Appendix 5

Comments and Responses

The Draft Environmental Impact Report (EIR) for the Valley South Subtransmission Project was circulated for public and agency review from January 29, 2016 to March 14, 2016. A public meeting was held on Monday February 22, 2016 at the Residence Inn Marriott (25407 Madison Avenue, Murrieta). The public meeting provided an opportunity for questions and comments to be heard, although these comments were not recorded or entered into the formal record. Attendees were advised to submit all comments in writing. During the review period, comments could be submitted by email, fax, or US Mail. At the public meeting, a comment form was provided to facilitate the submittal of written comments.

Valley South Subtransmission Project
Draft EIR Comments

A2-1

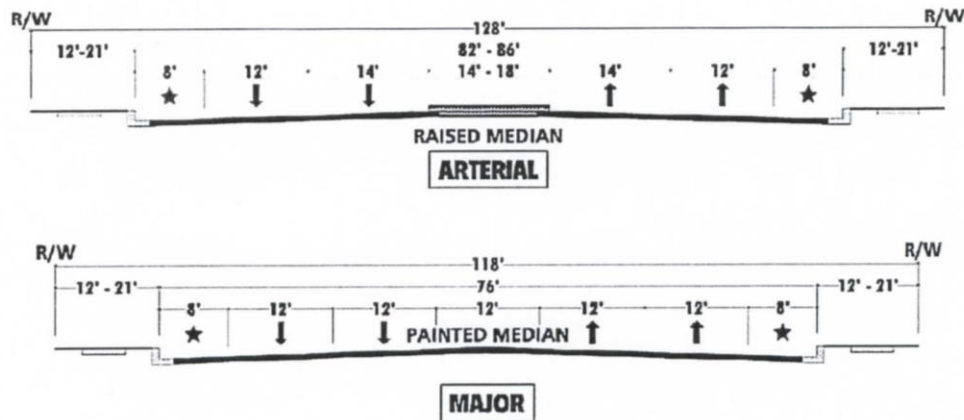
1. As previously requested in the City's June 4, 2015 NOP comment letter, SCE should take into consideration the recently approved (December 2013) City of Menifee Circulation Element when designing the power pole alignment within the City limits. The poles should be placed at their ultimate location per the City's Circulation Element roadway cross-sections. The poles should be located either within the right-of-way's parkway or completely outside of the public rights-of-way within a private easement, but they should not be placed within the ultimate planned pavement, curb, gutter, trails, or sidewalks. For your reference, Briggs Road is designated as a Major (4 lanes, divided) roadway, McLaughlin Road as a Collector / Interconnected Local (2 lane) roadways, Scott Road as an Urban Arterial (6 lanes, divided) roadway, and Menifee Road as an Arterial (4 lanes, divided) . Refer to the corresponding cross-sections below.

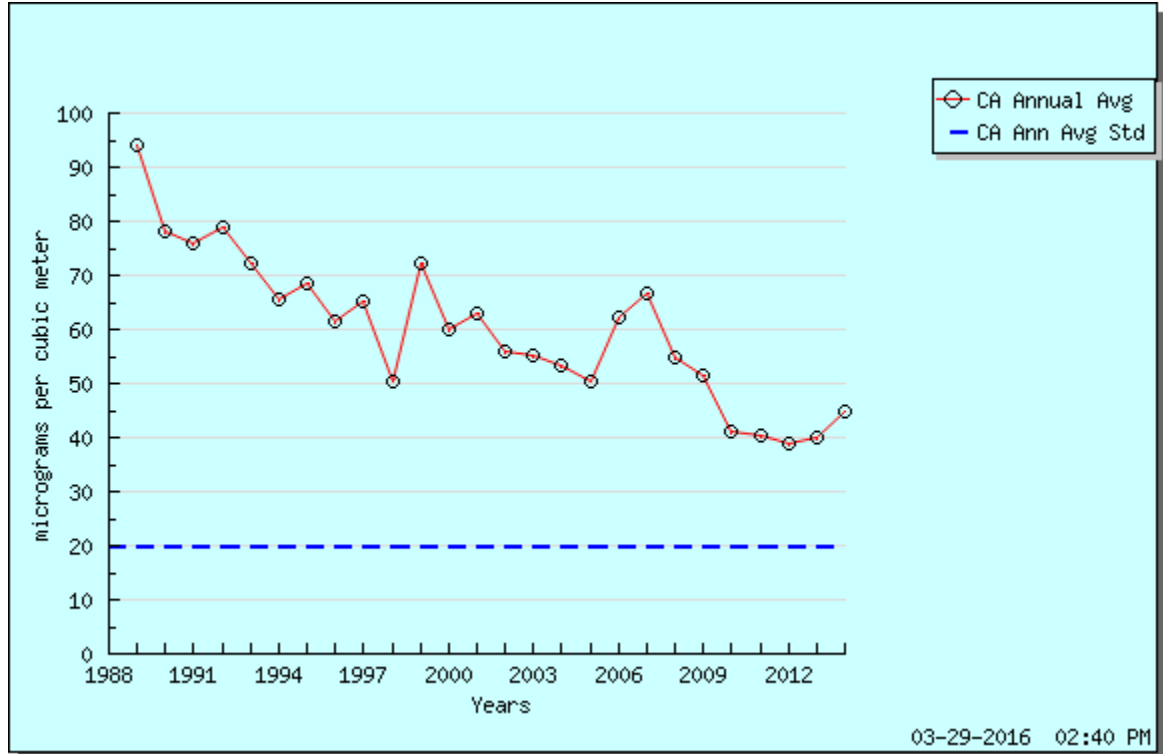
At C.4-10 you contend that you are not subject to the South Coast Air Quality Management District’s (“SCAQMD’s”) additional requirements under Rule 403 because you are not disturbing 50 or more acres of surface area. But you previously conceded that you are actually disturbing 193.5 acres. We believe the requirements which include a dust control plan should apply.

Additionally, South Coast Air Quality Management District (SCAQMD) Rule 403 does not actually require a fugitive dust plan for defined large operations, although such plans can be submitted. The requirement is the submittal of a Large Operation Notification along with recordkeeping to show compliance with the Large Operation requirements of this rule.

Text has been added to Final EIR Section C.4.2.3 (Local) under “South Coast Air Quality Management District” to clarify the Rule 403 requirements and the Project assumptions related to Rule 403 defined Large Operations.

COUNTY OF RIVERSIDE
TENTATIVE TRACT MAP No. 36467

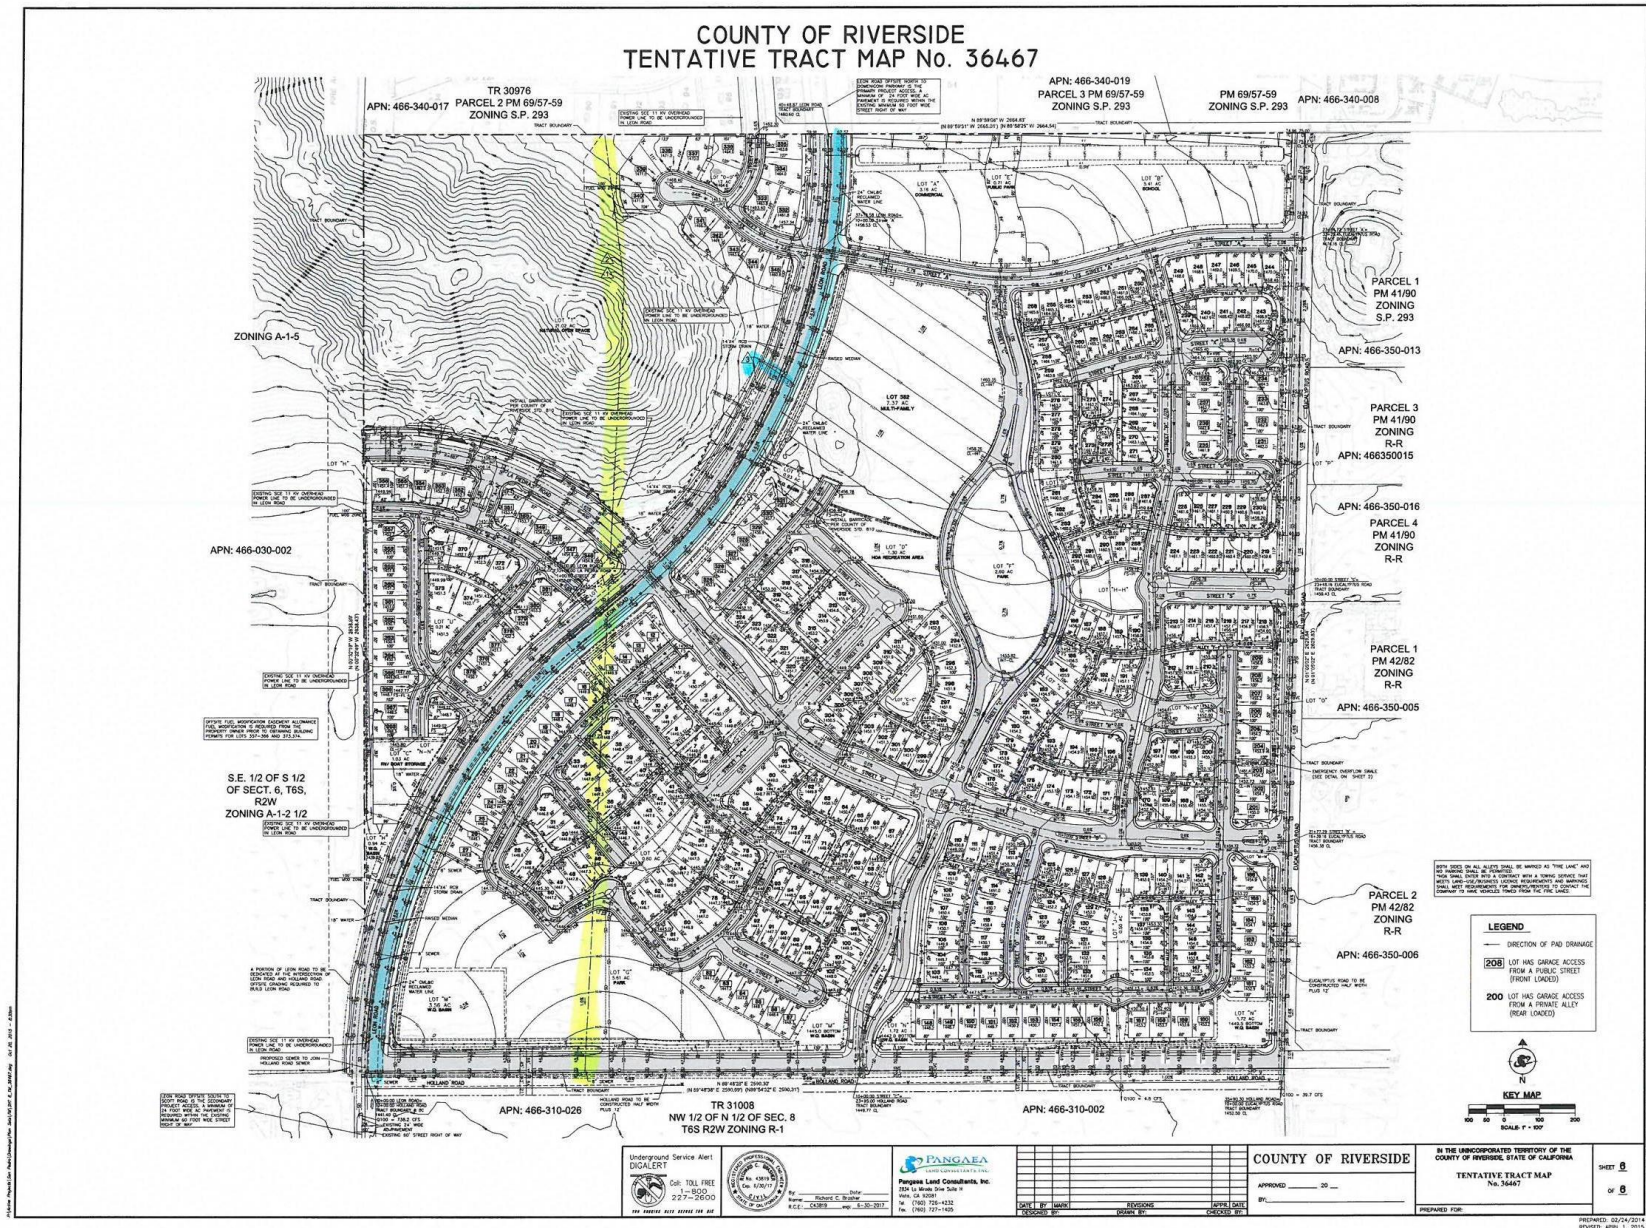
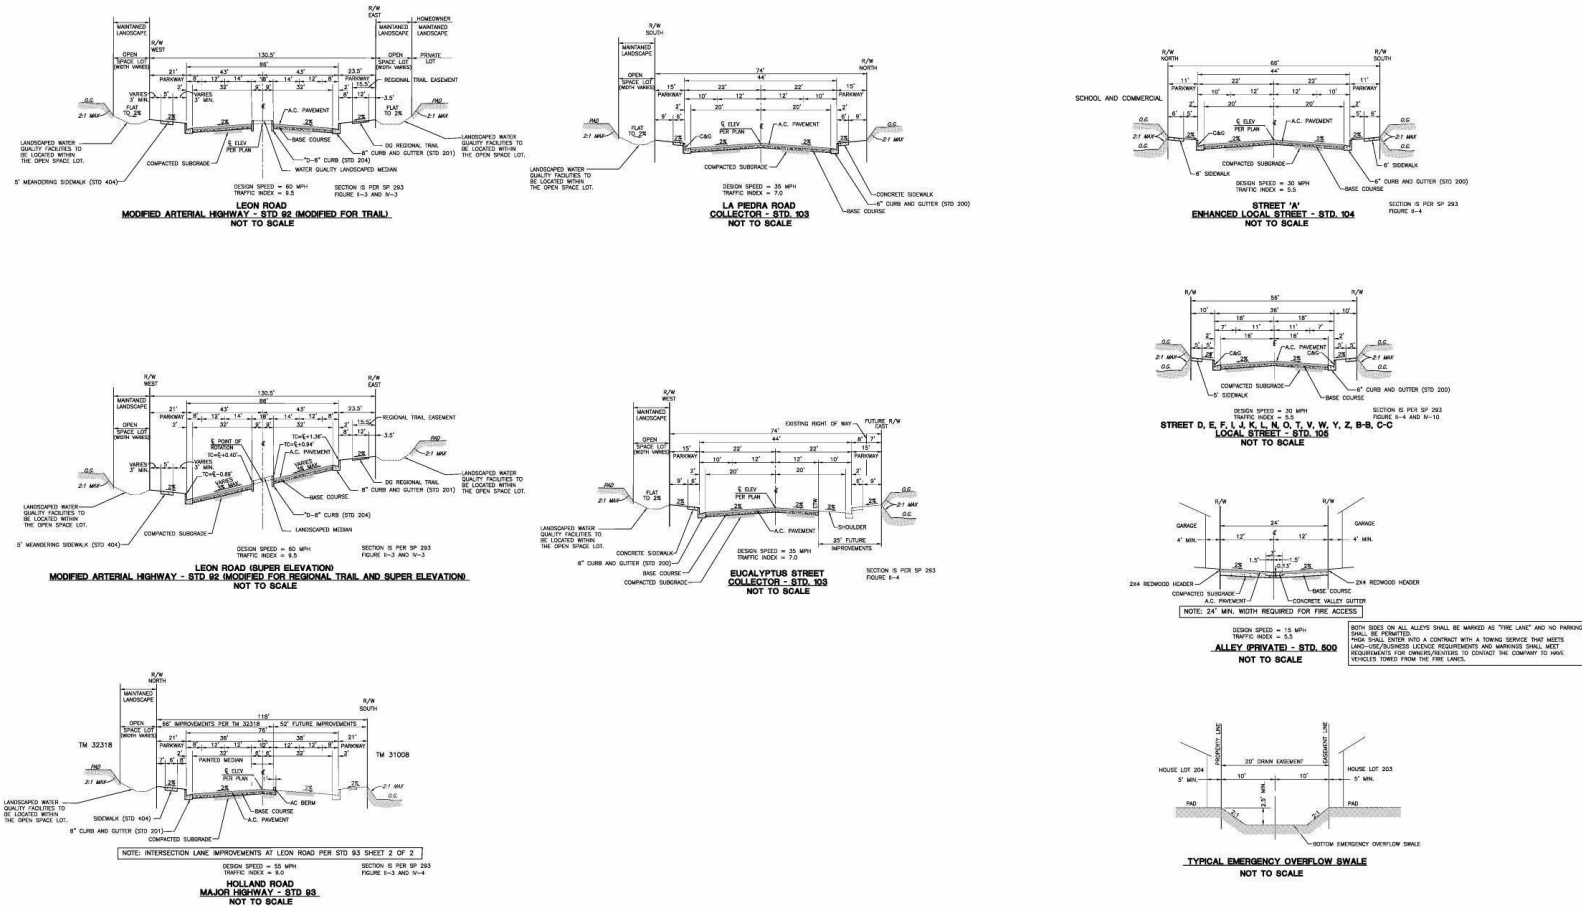
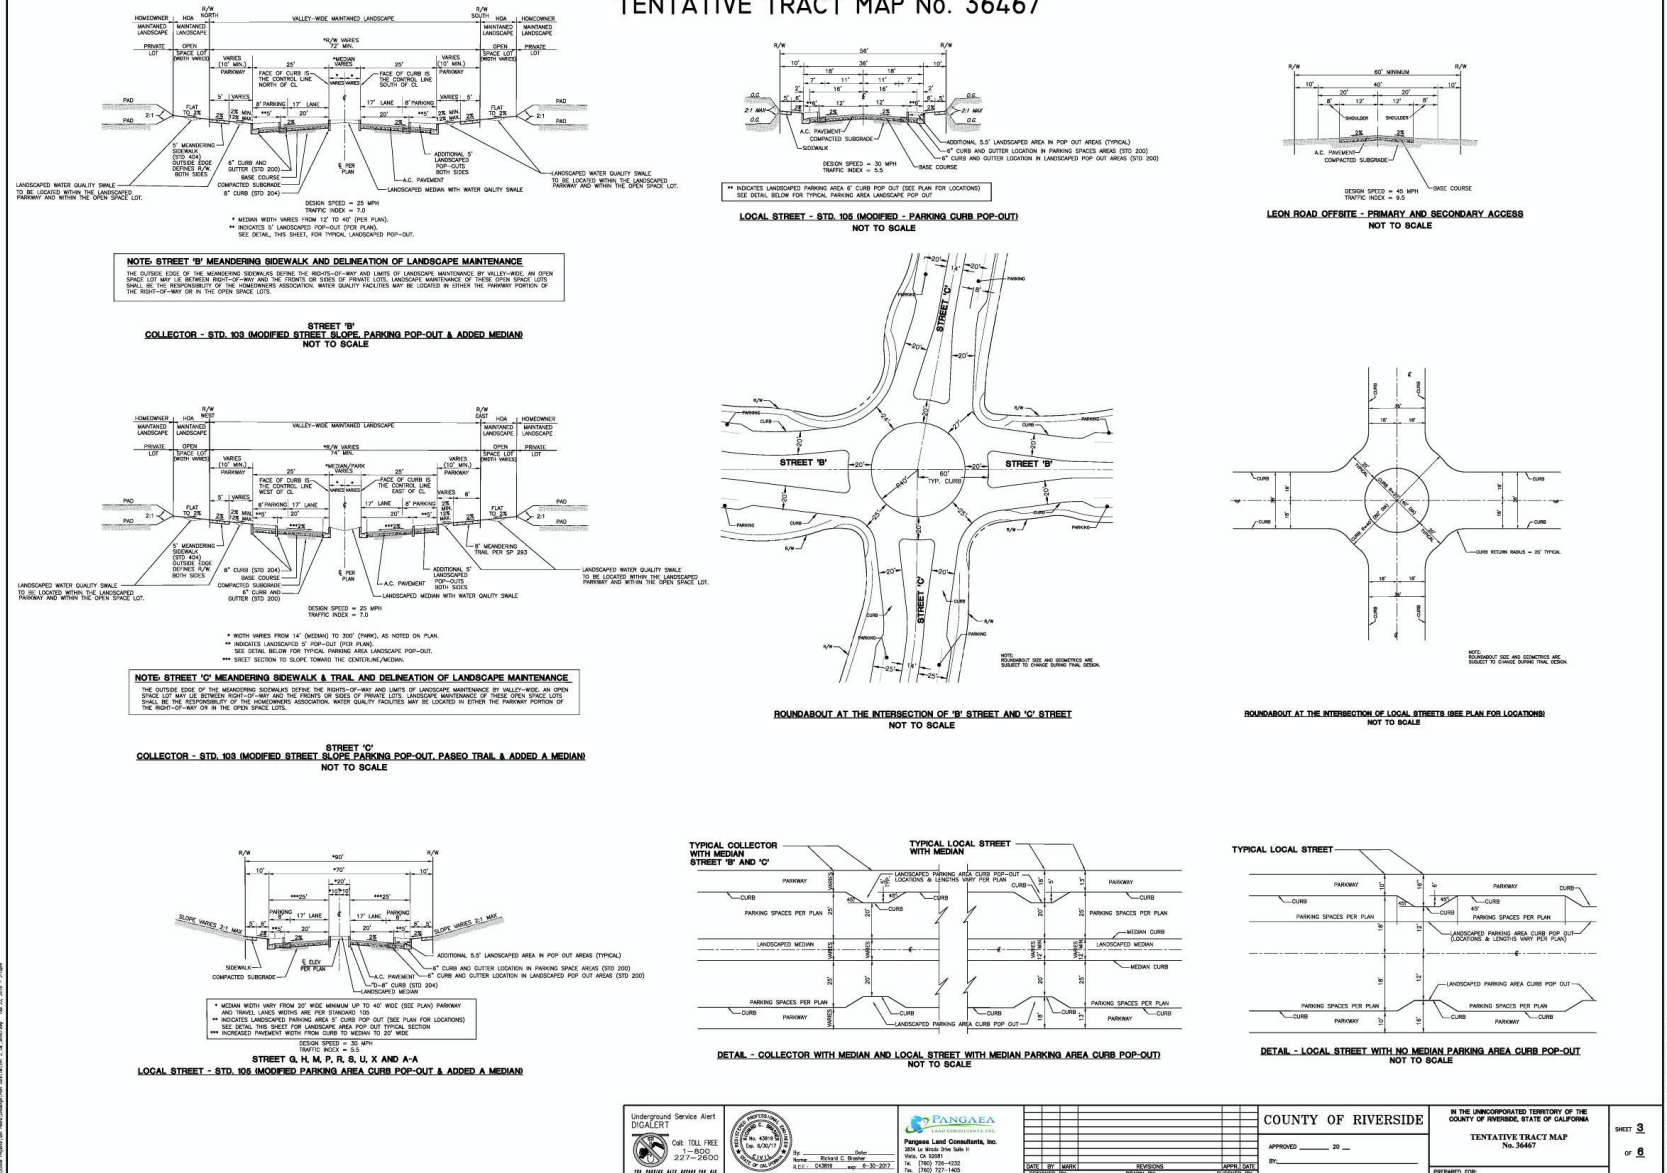
C9-1

C9-2

C9-1 Thank you for your comments regarding Tentative Tract Map 36467. During preparation of the Final EIR, the County of Riverside had not decided on this tract map and we were unable to obtain the environmental document or the staff report from the County. Even though the commenter states that the project will be approved, we could not verify what conditions or requirements would be placed on the project with regard to the realignment of Leon Road. To address this potential project, we have included a mitigation measure in Section C.11 (Land Use and Planning) that requires SCE to coordinate with the project developer for this potential project and other proposed projects near the Project alignment. The proposed (VSSP) Project is currently designed to follow the existing alignment of Leon Road, as generally shown in the following exhibit.
